T10/07-046r2

To INCITS T10 Committee
From Michael Banther, HP
Subject SSC-3 Requested Recovery log page

Date
5 September 2007

Figure 8 – UML example of SCSI target device and physical device

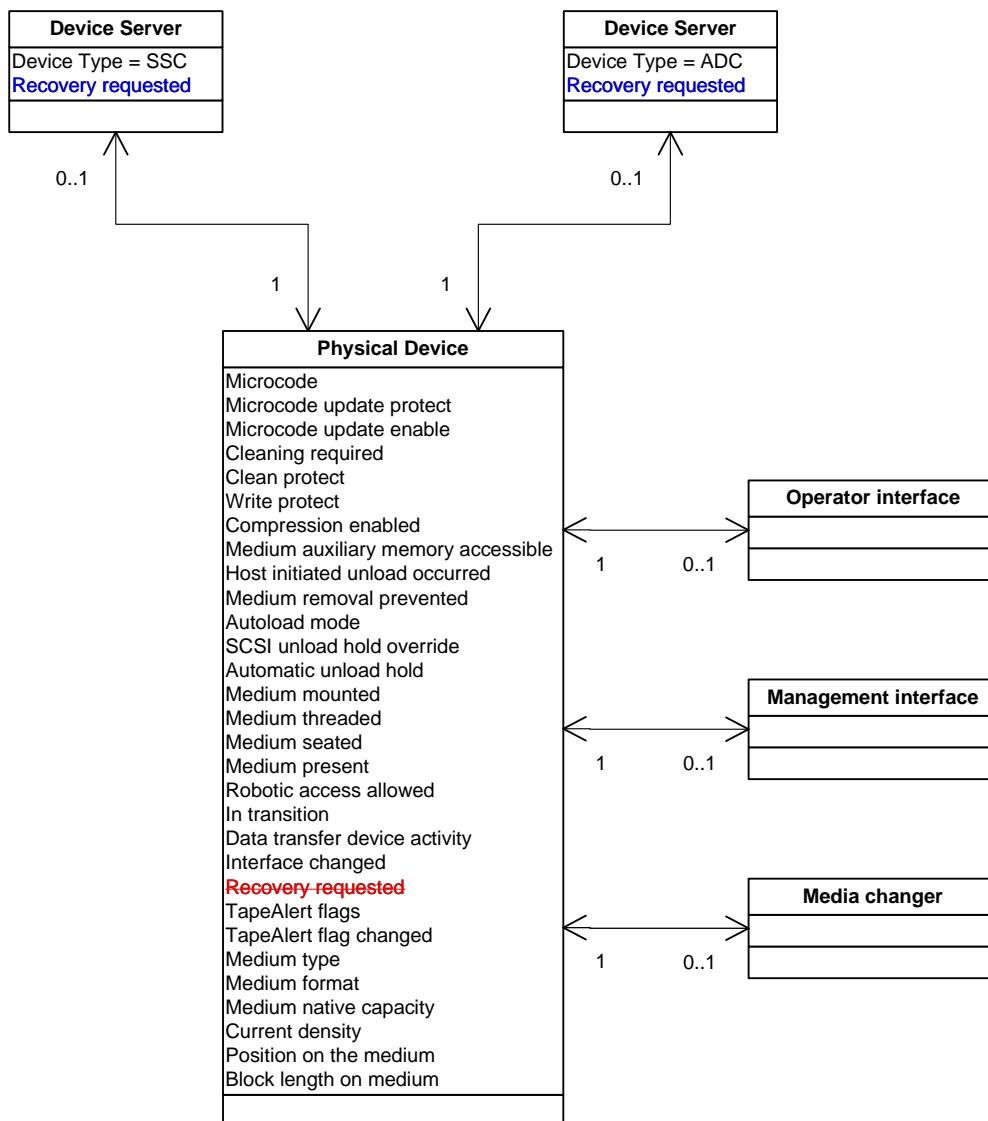
4.2.3 Physical device

These entities perform operations that change various attributes of the physical device. These attributes affect the operations on a volume. Figure 8 shows in UML notation an example of the entities in a SCSI target device, and shows the attributes which comprise the physical device.
